PRELIMINARY OVERALL AREA DEVELOPMENT PLAN for REGENCY MEADOW SUBDIVISION

REGENCY MEADOW SUBDIVISION : 238 RESIDENTIAL LOTS, 49.53 ACRES

RE: Regency Meadows, POADP #351

RE: Regency Meadow Subdivision POADP#351

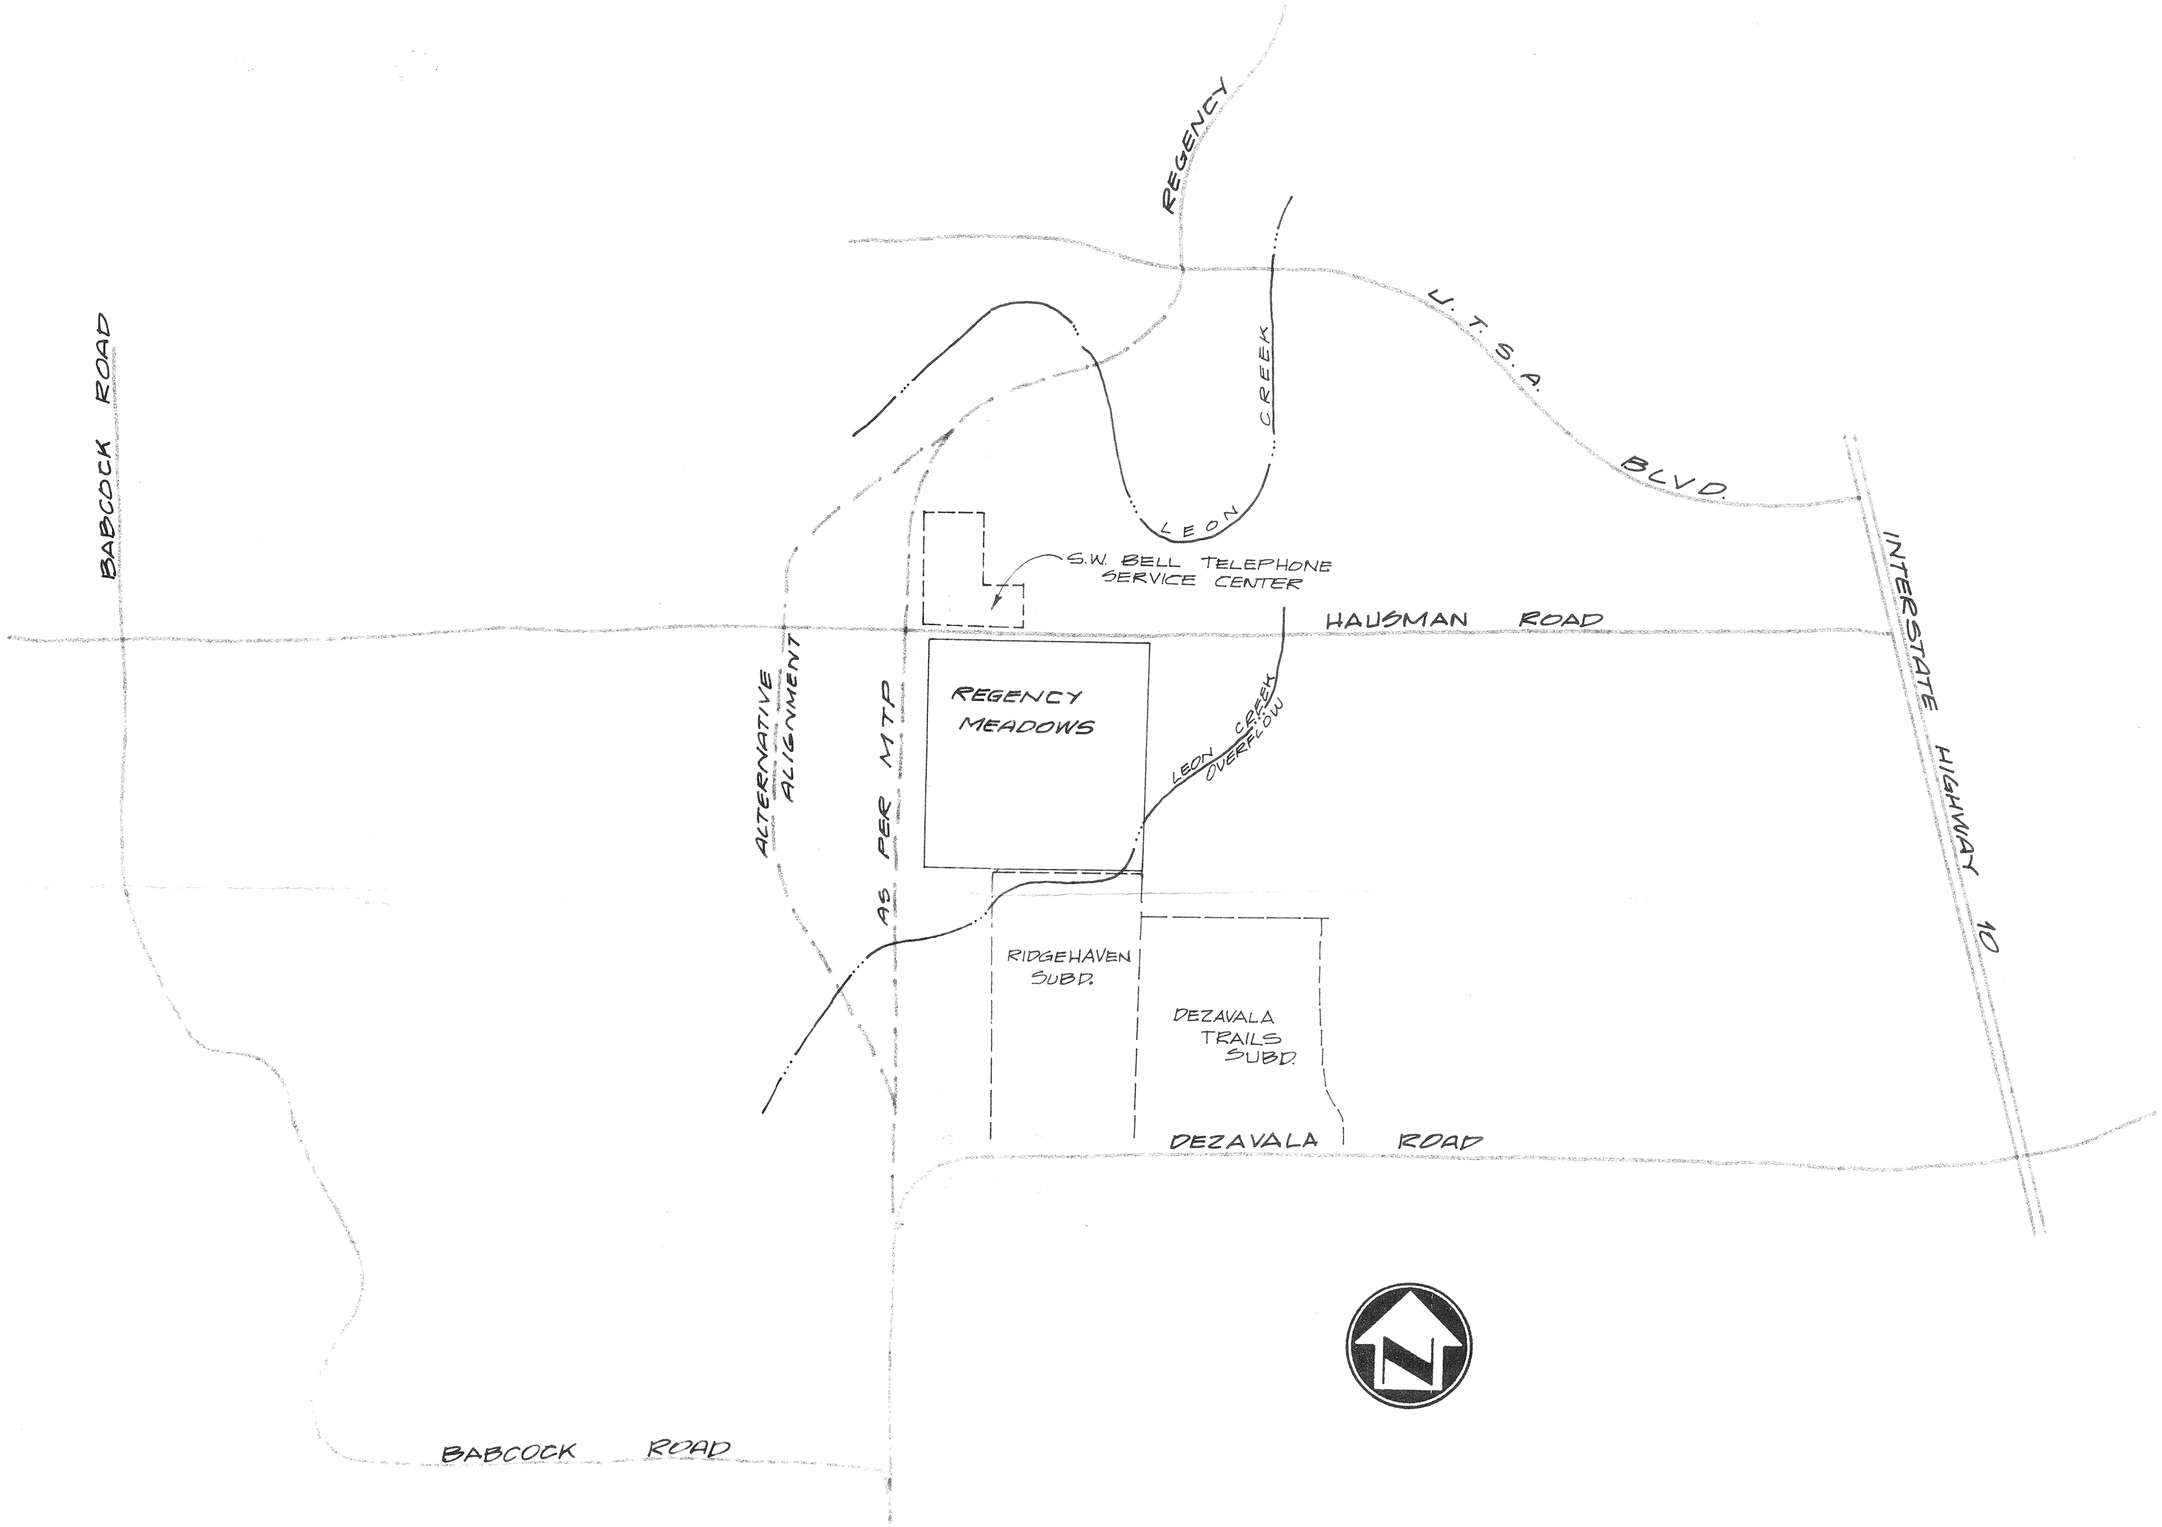
1. Your plan has three (3) unidentified strips of land along the southern perimeter in between lots. These need to be labeled approriately.

2. Adjacent to the southern perimeter, you have indicated the property to be "Ridgehaven Subdivision". You need to delineate the existing subdivision configuration that abuts your property.

3. Additionally, you will be required to place a non-access easement along the rear of the lots along Hausman Road at the time of platting.

4. It also appears that your unit/phase boundary is extending beyond your intended limit on the southwest corner of phase "A".
